D3016-041 SEAT FRAME ASSEMBLY

DRAWING NO. D3016	TITLE SEAT FRAME ASSEMBLY	REV. A	DART AEROSPACE LTD ENGINEERING ORDER	D.E.O. NO. D3016-A-1	SHEET NO. SHEET 1 OF 1	SCALE NTS
DRAWN <i>1</i>	CHECKED <i>UP</i>	MFG. APPR. <i>RE</i>	APPROVED <i>MP</i>	DE APPR. <i>MP</i>		
DATE 10.01.29	DATE 10.01.29	DATE 10.01.29	DATE 10.01.29	DATE 10.01.29	DATE 10.01.29

PURPOSE:

TO REVISE D3016-11 SADDLE'S HOLE SIZES

D3016-11 SADDLE

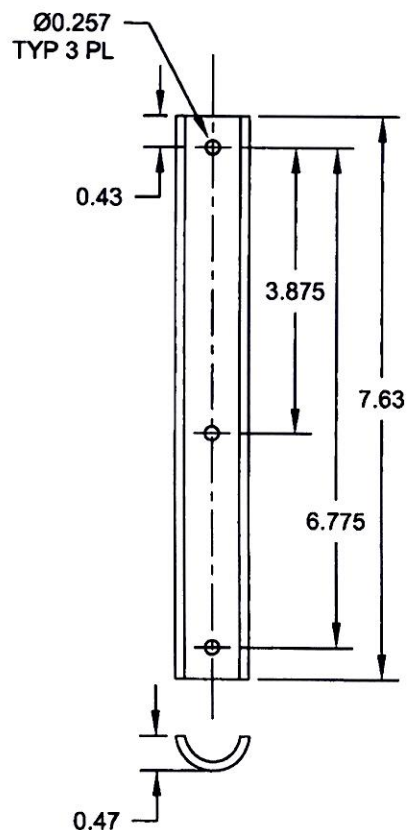
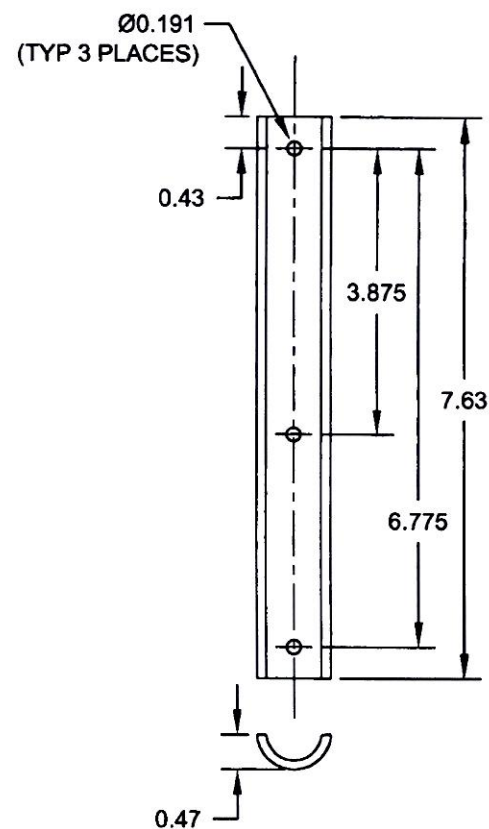
DETAIL D3016-11 SADDLE (SHEET 3): Ø0.257 TYP 3 PL WAS Ø0.191 (TYP 3 PLACES) AS SHOWN:
